# **Report of Staff Recommendation**

File No.: 7-A-23-TOB

Request: BUILDING PERMIT

Proposed Land Use: New Office-Warehouse building

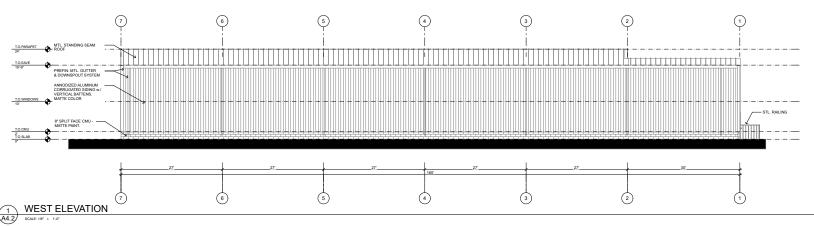
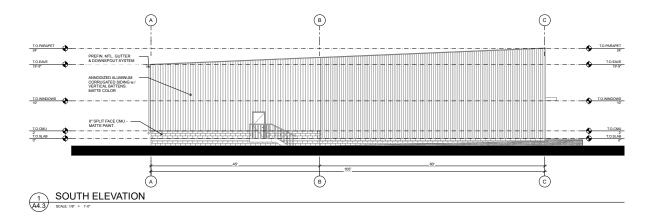
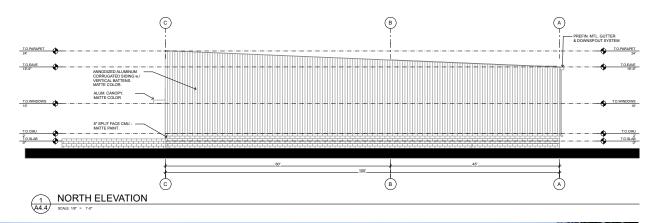
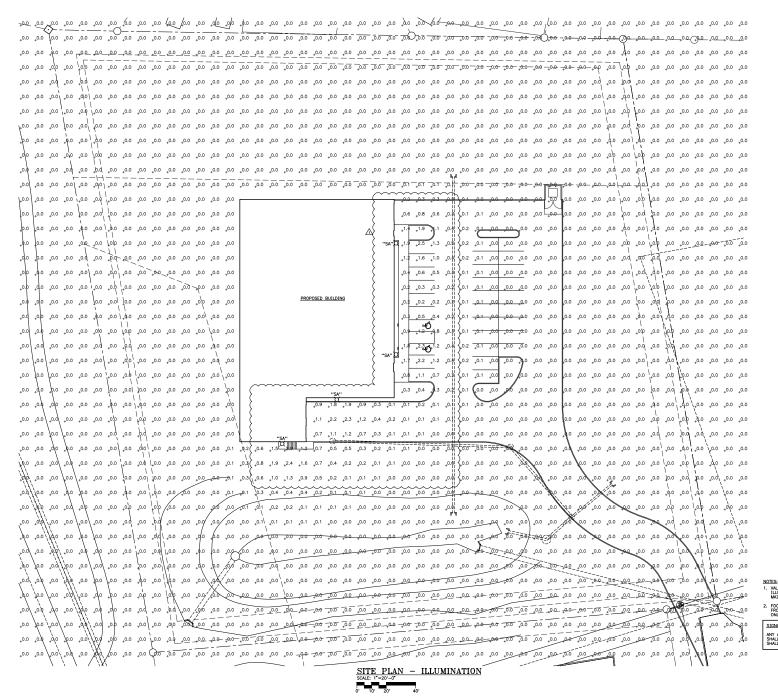
- 5) The building facade features aluminum siding on all facades and on the loading dock doors. The main building entry consists of a storefront system capped with an aluminum canopy, and a secondary entry that is also on the front façade is capped with a smaller aluminum canopy. The building is slightly taller in the front than in the back, so the roof slopes slightly from front to back, but is otherwise flat.

- 6) Use of metal panels and masonry block is not prohibited but is discouraged. Foundation plantings are proposed to screen the materials used. The landscape plans call for a series of Emerald Arborvitae, a narrow, vertical tree, that will help to soften the building's appearance and provide visual interest to an otherwise blank façade.

SITE PLAN - ILLUMINATION

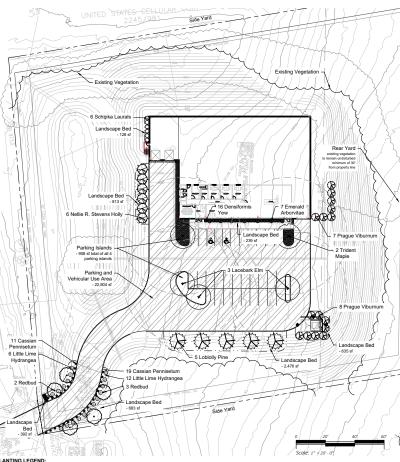
- 9) The proposed lighting includes 5 building-mounted fixtures for safety and security purposes. These are located along the front façade of the building along the parking lot and loading area. The proposed light fixtures are full cut-off and utilize LED lighting, thereby meeting the TTCDA Guidelines. The lighting levels exceed the maximum allowed by the TTCDA Guidelines.

L100

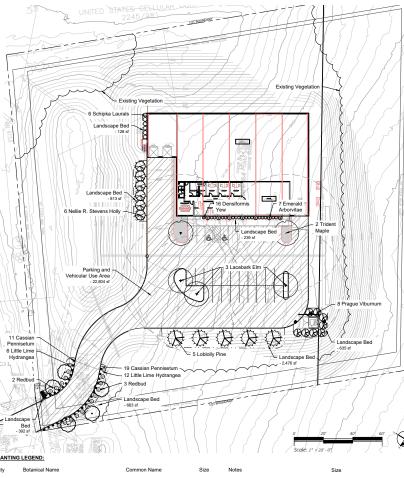
- 7) The landscape plan meets the landscaping requirements of the TTCDA Guidelines.
- 8) The subject property abuts single family residential neighborhood on the north, and an apartment complex is under construction on the west. A Type A Dense landscape screen is required between commercial and residential areas. To meet this standard, the site plans identify a 15-ft non disturbance area (the minimum required) on the western lot line, and a 30 ft non-disturbance area along the northern lot line (Planning had requested a minimum of 25 ft).
